SUBJECT: Calvert Cliffs Nuclear Power Plant
Unit No. 1; Docket No. 50-317
Core Operating Limits Report for Unit 1 Cycle 15, Revision 4

CORE OPERATING LIMITS REPORT

UNIT 1, CYCLE 15

REVISION 4

Figure 3.2.1-1

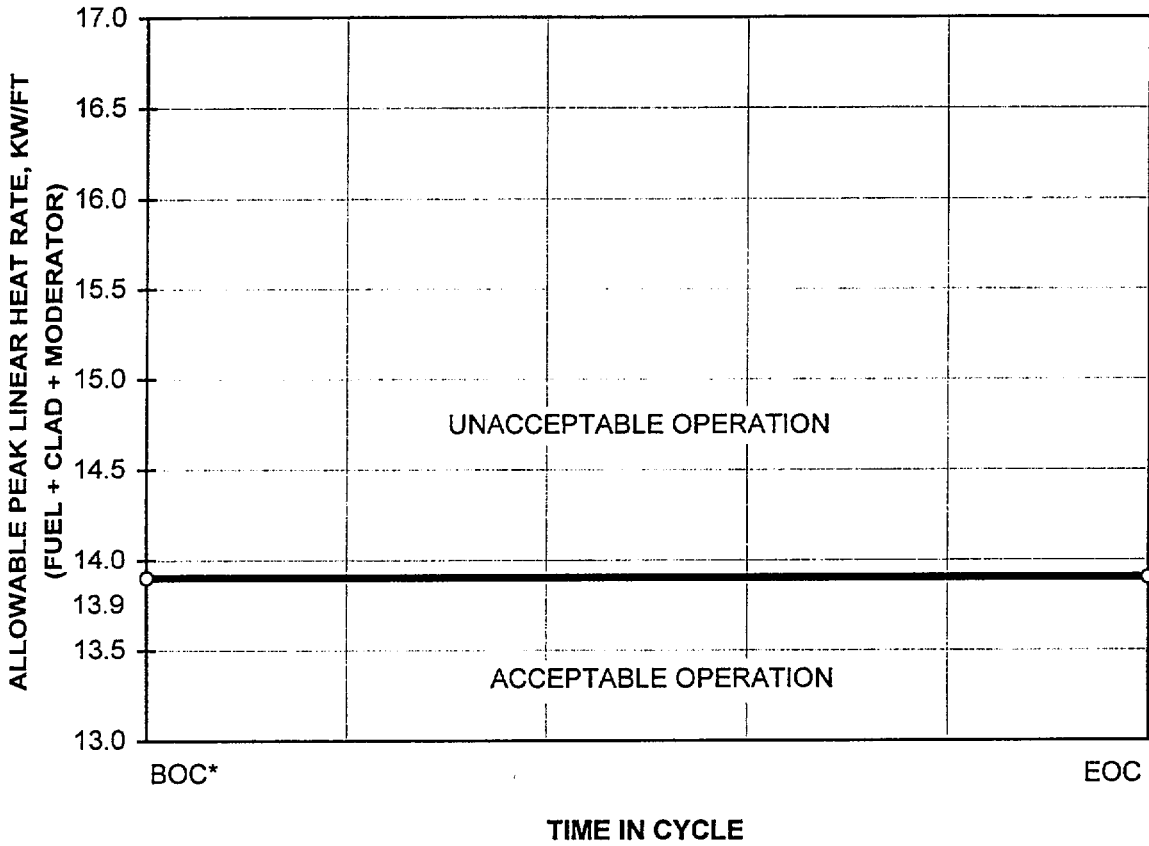
Figures 3.2.1-1 and 3.2.1-3 are revised to lower the allowable PLHR from 14.3 kw/ft to 13.9 kw/ft. Figures 3.2.1-3, 3.2.2, & 3.2.3 are revised to expand the tradeoff curves below 80% power. Finally, Figure 3.2.5 and the list of references are revised to implement the ABB-NV setpoints. (SE00451, Rev. 0000).

*Allowable PLHR was changed from 14.3 kw/ft to 13.9 kw/ft mid-cycle
